ECE/TRANS/WP.29/GRRF/2002/17/Rev.6
10 July 2006

Working Party on Brakes and Running Gear (GRRF)

**REVISED PROPOSAL FOR DRAFT AMENDMENT TO REGULATION No. 64
(Temporary use spare wheels/tyres)**

Transmitted by the expert from the United Kingdom

Paragraph 5.1.4.1., amend to read (the diagram is not amended):

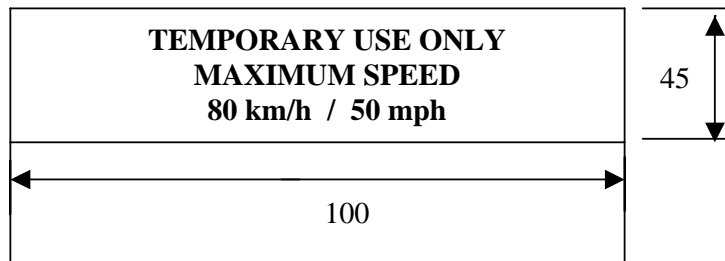
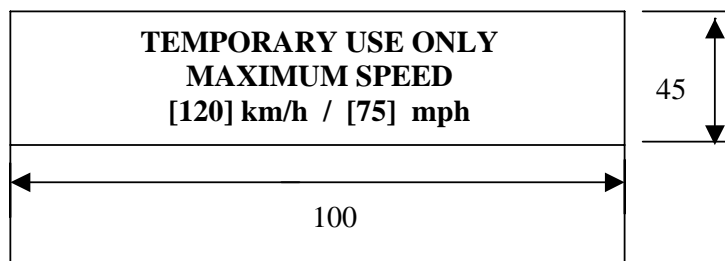
"5.1.4.1. An 80 km/h maximum speed warning symbol arranged in accordance with the diagram below shall be permanently displayed on the outer face of the wheel in a prominent position.

In the case of vehicles intended to be sold in countries using imperial units of measurement, an additional warning symbol, identical to that described above, with the exception that the figure "80" shall be replaced by "50" and the wording "km/h" by "mph", shall be permanently displayed on the outer face of the wheel in a prominent position.

Alternatively a single warning symbol arranged in accordance with the diagram below, shall be permanently displayed on the outer face of the wheel in a prominent position.

Upper case letters shall be at least 5 mm high and the numbers "80" and "50" shall be at least 20 mm high with the elements that make up each character of the number at least 3 mm line thickness. Lower case text shall at least have a line height of 5 mm. All text shall be enclosed in a border and be on a background of contrasting colour.

The requirements of this paragraph shall only apply to types 1, 2 and 3 temporary use spare unit as defined in paragraphs 2.4.10.1., 2.4.10.2. and 2.4.10.3."
